Delegated Report

Householder Planning Application

Planning Application No: 20250930

Location: 9 Gazelle Glade Gravesend Kent DA12 4PU

Proposed Ground Floor Plan
Scale 1:50

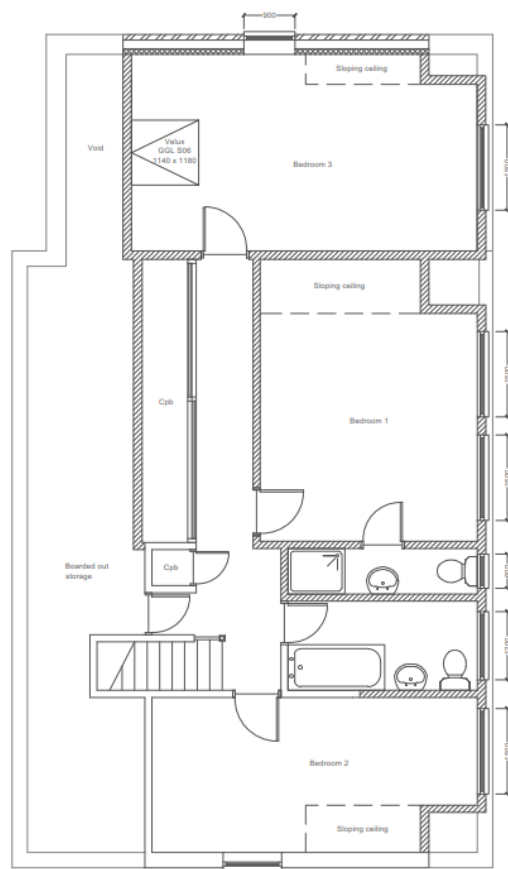
An extended roof dormer is proposed now only at full length on the south side (where there is no neighbouring property) so the previous privacy concern has been addressed. The appearance of the proposed dormer is satisfactory with the bulk of the dormer roof subservient to the roof ridge, except on the new extension however such a non-subservient design has previously been permitted by GBC in the immediate area.

A new roof window is proposed on the northern side, this should have a sill height at 2m or greater above the adjacent floor level.

Upon review of the plans submitted for this current application, it was noted that some alterations had been made since the previous refusal, however, concerns remained in relation to the excessive scale of the dormer. The agent was contacted to request that the dormer be removed entirely from the roof of the proposed extension. The agent provided amended plans, not removing the dormer from the extension roof, but separating the proposed dormer into two smaller dormers to reduce the overall scale and bulk. As such, it stands to be assessed whether the revised plans overcome the previous grounds of refusal and whether any new concerns are raised.

In addition to the proposed dormers, a 3.80m depth rear extension is proposed which has been reduced in scale slightly since the previous application. It would be largely constructed to the parameters of the existing dwelling but does show some subservience by being set down from the main roof ridge, and by not being a full width extension. It is noted that some properties within the area have extended to the front in a similar way and therefore the extension is on balance, considered to be acceptable.

Taking the above considerations into account, the proposal is, on balance, considered to accord with Policy CS19 of Gravesham's Local Plan Core Strategy (LPCS) (2014) and Section 12 of the National Planning Policy Framework (2024). As such, the previous grounds of refusal 1 are overcome.
